GLASS IN THE ROCKS

**Some Issues Concerning the Disposal of Radioactive Borosilicate Glass in a
Yucca Mountain Repository**

**Prepared for the
Nevada Nuclear Waste Task Force
and the
Nevada Agency for Nuclear Projects
Nuclear Waste Project Office
State of Nevada**

January 29, 1991

FIGURE 1. Defense high-level waste borehole waste package conceptual design.

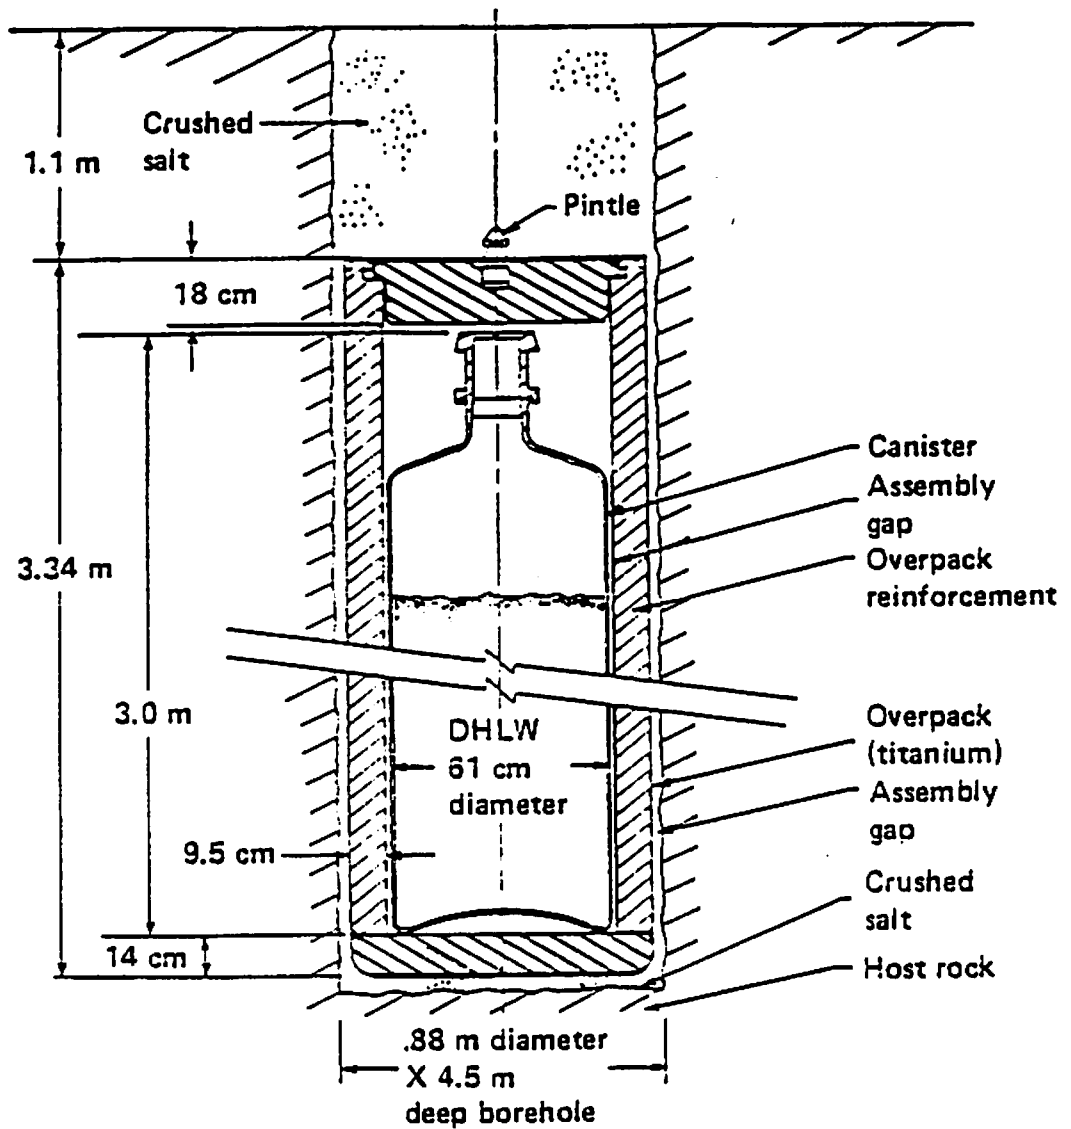
The waste form is one part of a planned system of barriers for preventing radionuclides from the waste form reaching the human environment in quantities that exceed that radionuclide release or dose criteria. The other parts of the system are: a canister in which the waste form is to be placed; an "overpack" of metal such as titanium; and backfill in the borehole where the package is to be placed. This constitutes the "engineered barrier system." Finally, there is the geologic system in which the engineered system is located, which is considered the primary barrier to prevent or retard radionuclides from reaching the human environment. Figure 1 shows the conceptual design of military high-level radioactive waste package.

FIGURE 2. Individual radiation dose as a function of water travel time in tuff: reprocessing waste from 10^5 Mg uranium fuel, congruent dissolution, no dispersion.

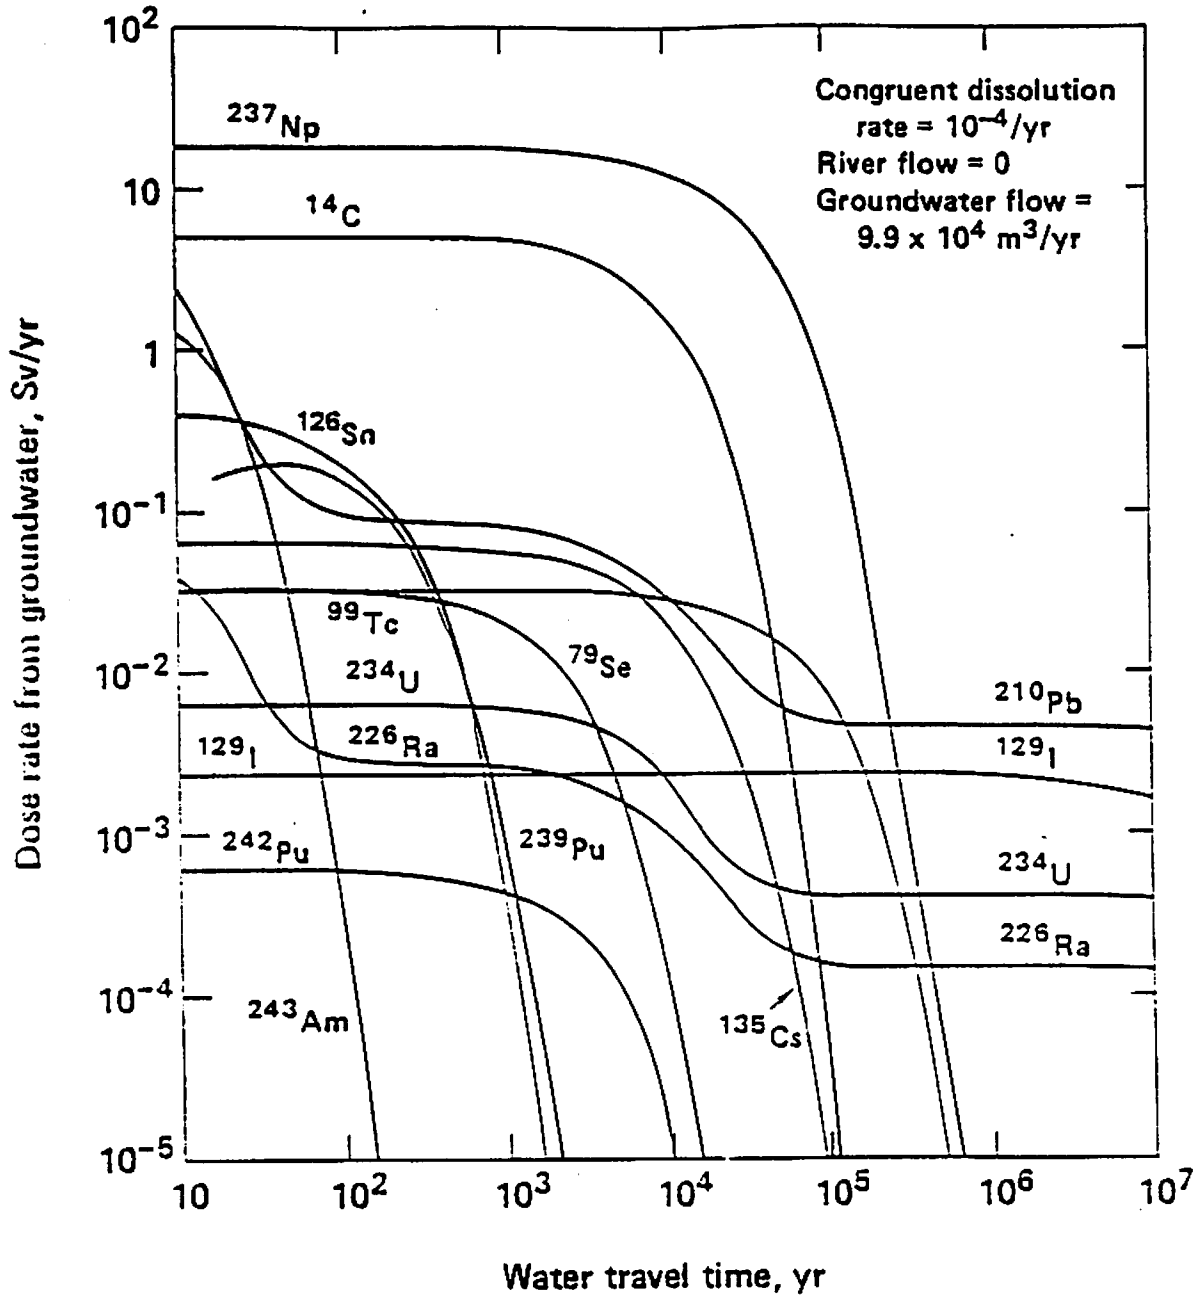
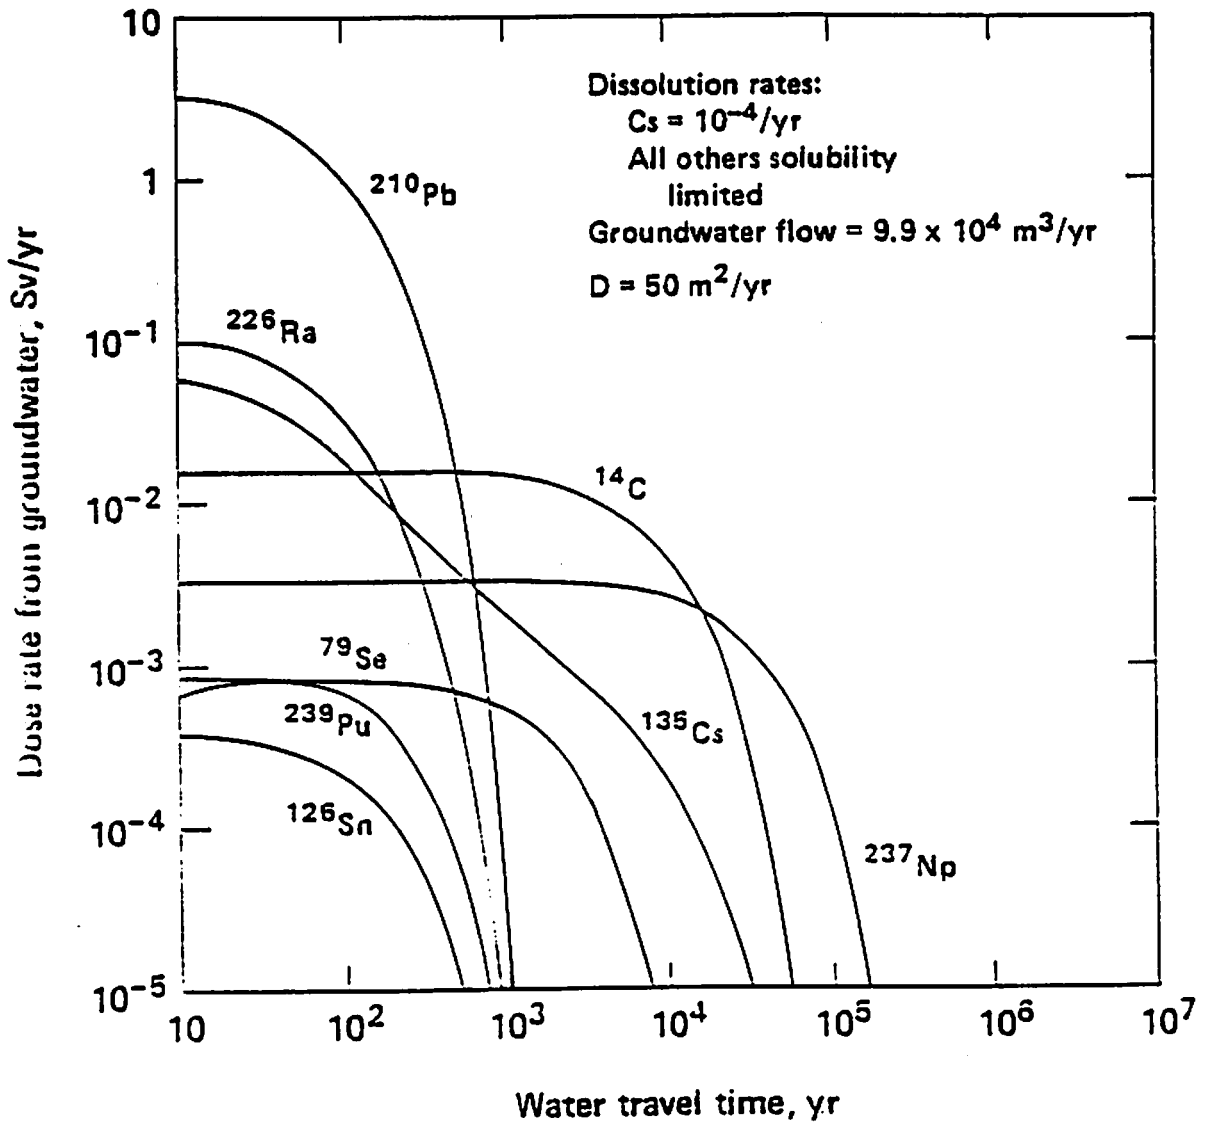
Figures 2 and 3 show the congruent dissolution and solubility-limited dissolution graphs for reprocessing waste, as reported by the NAS study. The study did not report similar calculations for unprocessed spent fuel in Nevada tuff, but the general effect would be the same, though the specific ratio would be different due to different radionuclide composition of spent fuel. The radionuclides released, as shown in Figures 2 and 3 would be broadly similar to those from glass containing military high-level wastes, because the figures assume that civilian fuel has been reprocessed, with most plutonium and uranium removed prior to vitrification.

The principal reason for concern about the phenomenon of hydration aging is that whatever the assumptions about solubility, it could cause radionuclide releases from hydrated surfaces to approach those for congruent dissolution.
